1-NSW-72 (Sheet 1 of 2)
 Upper Containment Ventilation
 Unit 1 Return Line

DOWN LGR DATE: 7-23-71 CONTAINMENT BLDG
 CKD: GN DATE: 7-30-71 DWG. NO. _____ REV. _____
 ISSUED _____
 REF. DWG. 1-5489A 1-NSW-72 SH 1 OF 2 4

SECTION "A-A"

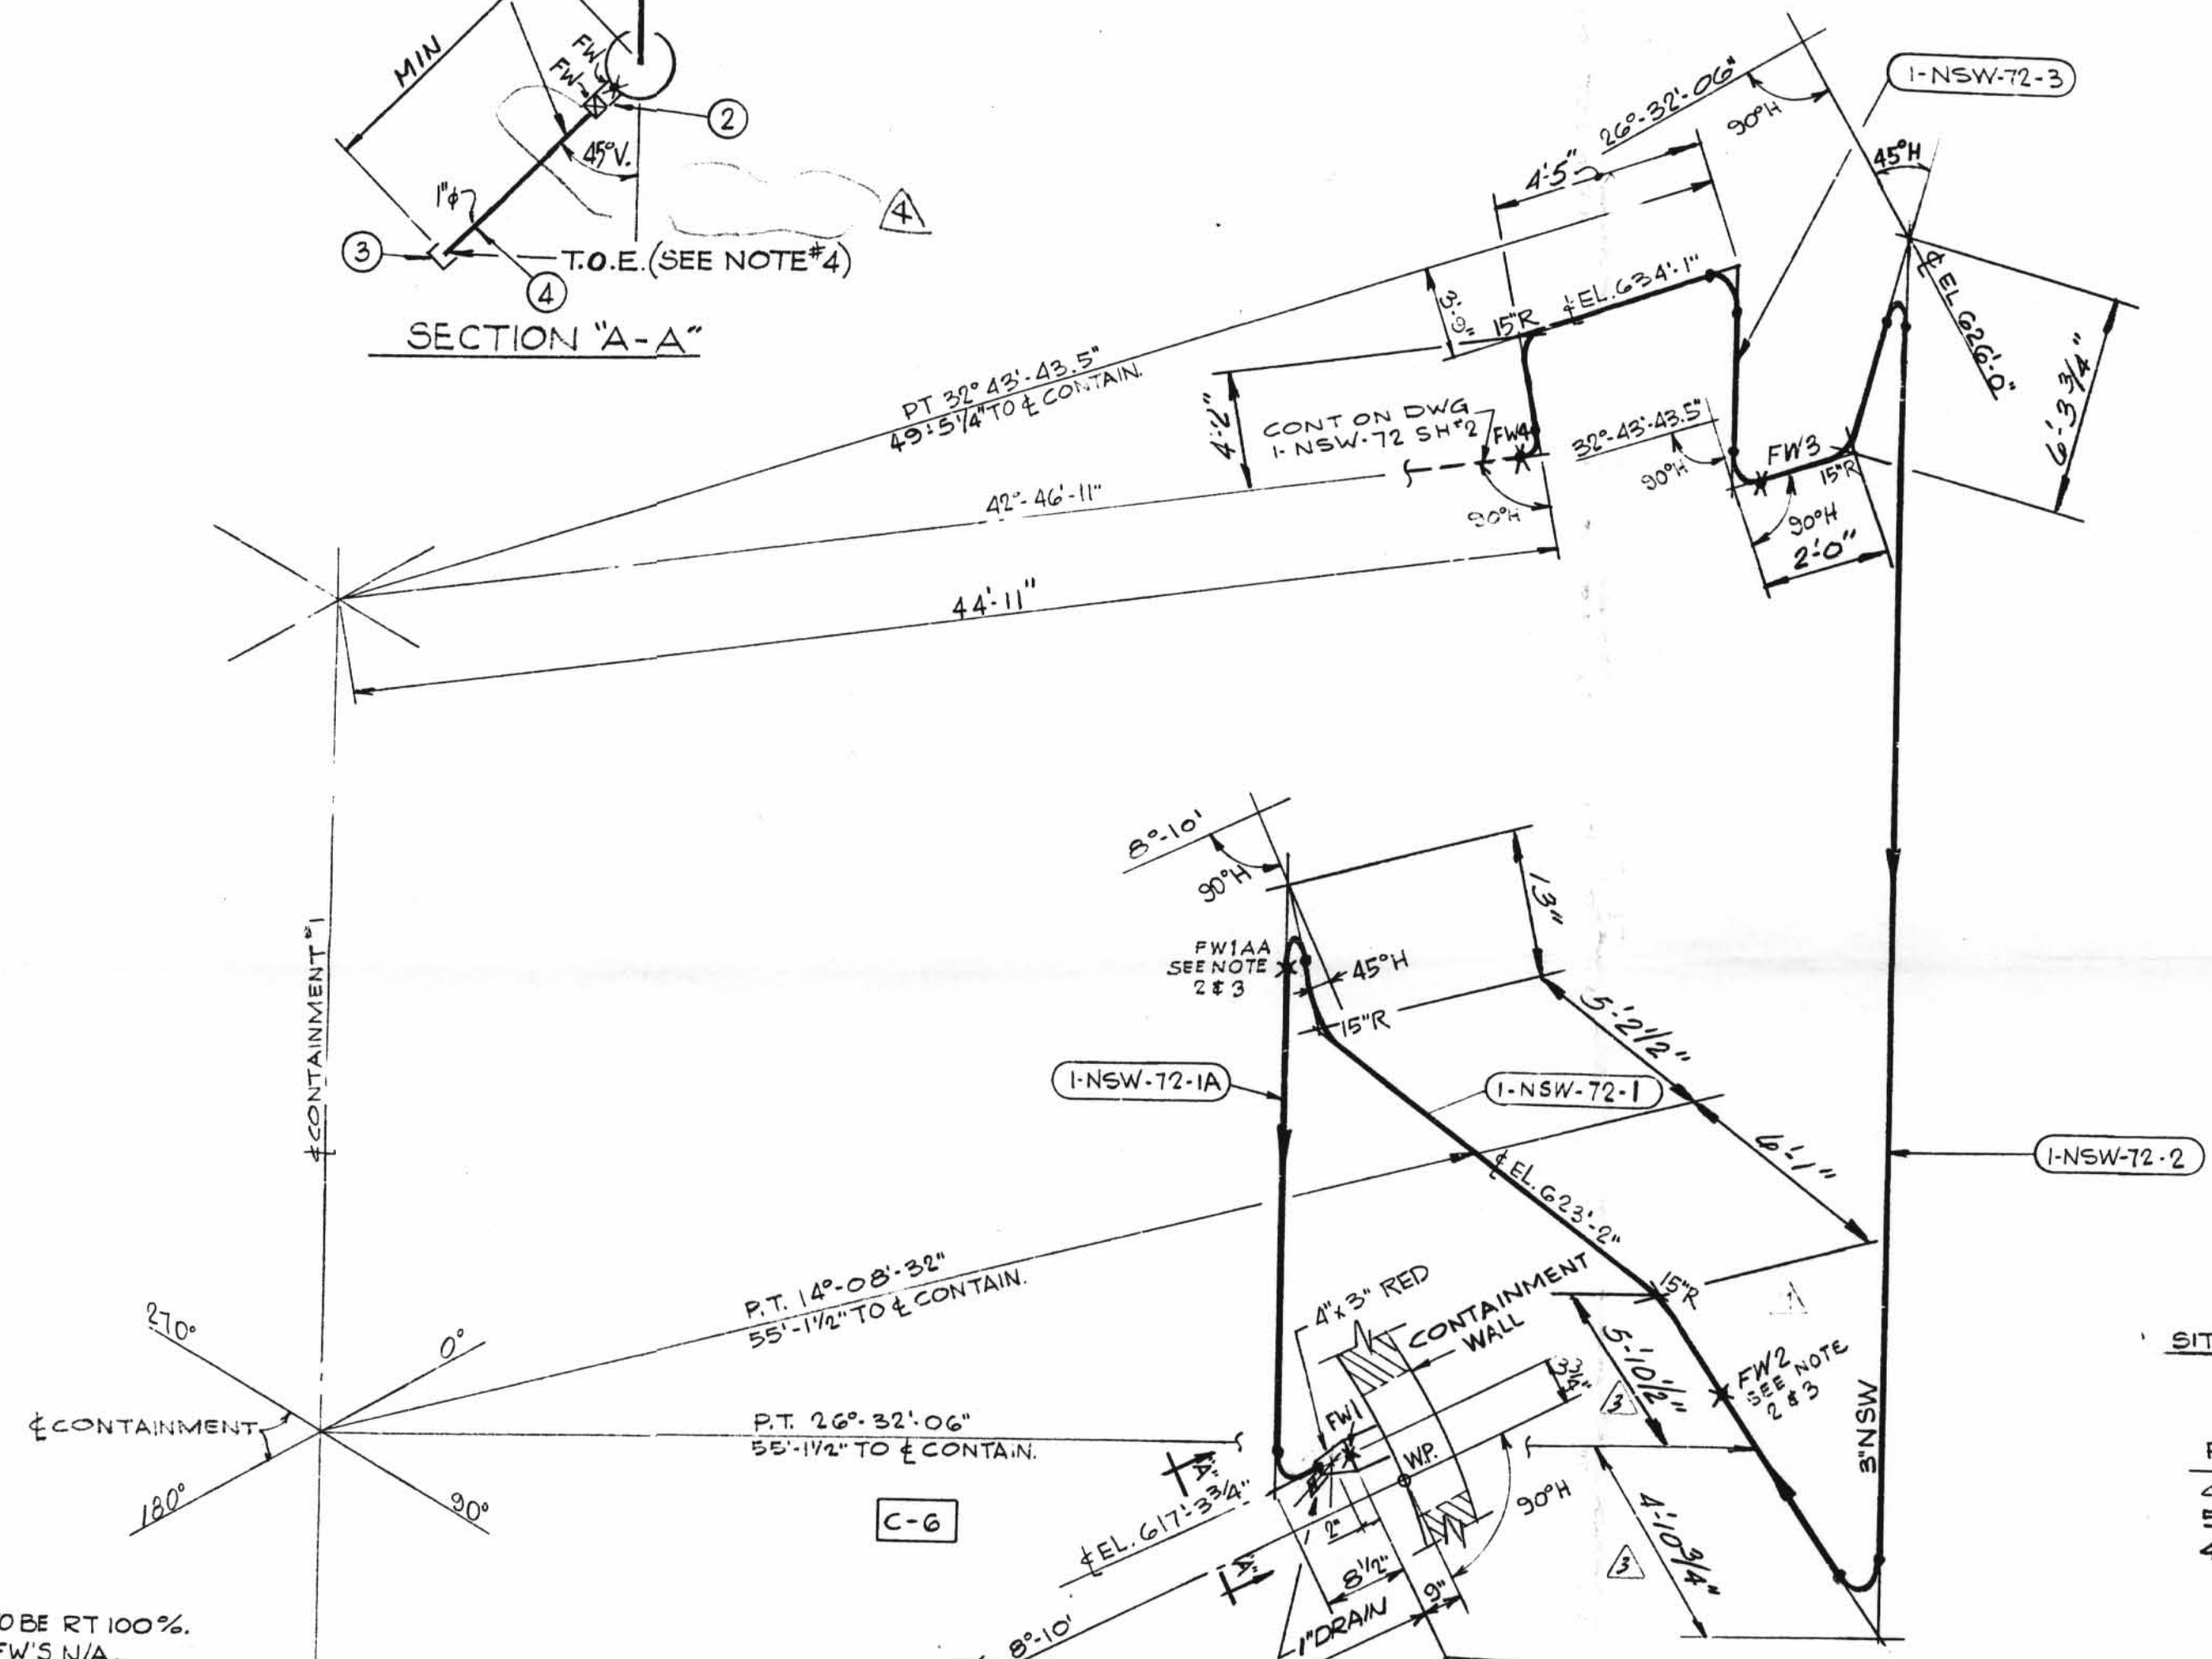
REV.	DATE	DR	CHK	DESCRIPTION	REMARKS
1	12/2/71	S.G.	GN	RELEASED PIPING AT CPN ADDED: FW1A; PC MK 1A; PO. # DESIGN CODE STAMP; NOTES 2 & 3; TOTAL NO. OF FW. REVISED: WELD PROCEDURE, PER DWG 1-5489A	FIELD ACTION RECD FAB ACTION RECD
2	1/12/72	RJG	LGR	ADDED: ITEM'S 1 THRU 4 TO B.M. SECTION 'A-A' PC-MK-1-NSW-72L3 NOTE #4. DELETED WELD PROCEDURE TO SUIT A.E.P. ARRGT DWG 1-5489A-3	FIELD ACTION RECD
3	1/19/73	GR	RJG	REVISED BY N.P.S. DESIGNS. ADDED: NOTE 5, DIM. 4'-2" 4'-5" 2'-0" 6'-334" 13" 5'-2 1/2" 6'-1" 5'-10 1/2" DIM. 4'-10 3/4" WAS 4'-9" 4'-11" WAS 4'-5" 4'-9" 5'-14" WAS 4'-5" 4'-9" PER AS BUILT DIMS A.E.P. DWG. NO. 1-5489A-4	NO ACTION REQ'D
4	3/7/77			AS PER RFC-DC-01-2007 REMOVED VA. AT SECTION A-A
